220001 - Pilu 80 Undercliff Road Freshwater - Response to Council RFI - R1

SUBJECT: **Pilu, 80 Undercliff Road, Freshwater – Response to Council RFI – September 2024**

DATE: Updated 7 March 2025
To be read in conjunction
with latest PWNA Acoustic
Report Revision 5.

Pulse White Noise Acoustics Pty Ltd (PWNA) has been requested to undertake a review and response in relation to the *Northern Beaches Council Environmental Health Unit Referral Response* dated 23rd August 2024 for the DA2024/0946.

Figure 4 **Extract – PWNA Pilu Acoustic Assessment**

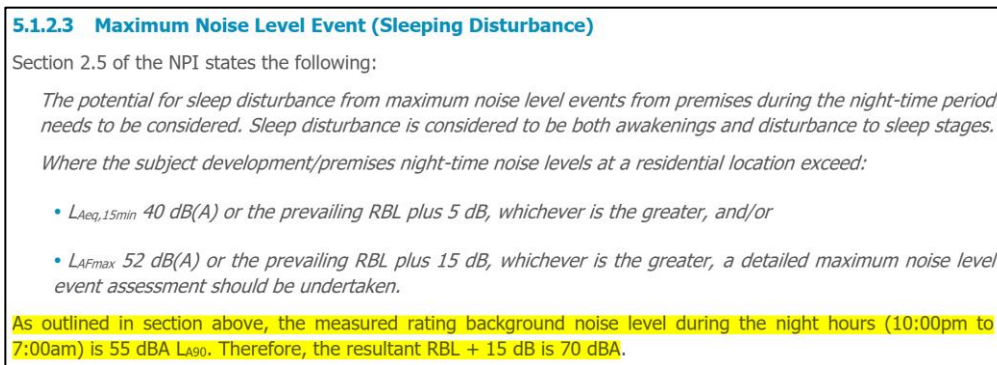
The AAAC guideline must be used for this assessment. All noise generating activities must be revised and the new outcomes must be presented. Figure 1 presents the layout of the existing venue, it can be seen that it has multiple internal and external areas. The scenarios presented in Section 6.1.2 provide insufficient information and are not representative of a real event. For example, the venue has 4 different external areas. Detailed scenarios, including the number of patrons, activities carried out and any other relevant noise generating activity i.e. live bands, DJs and the effect of door being open must be clearly detailed.

- Paragraph 3:
 - A lack of understanding of the site and associated development application is evident in the RSA comment. The site does not contain any “industrial” or “carparks”.
 - In relation to the mechanical plant, compliance is already achieved. Again, no alterations to this existing system are currently proposed.
 - No further comment required.
- Paragraph 4 & 5:
 - The criteria are not incomplete. Refer to the report and the extract provided below.
 - No further comment required.
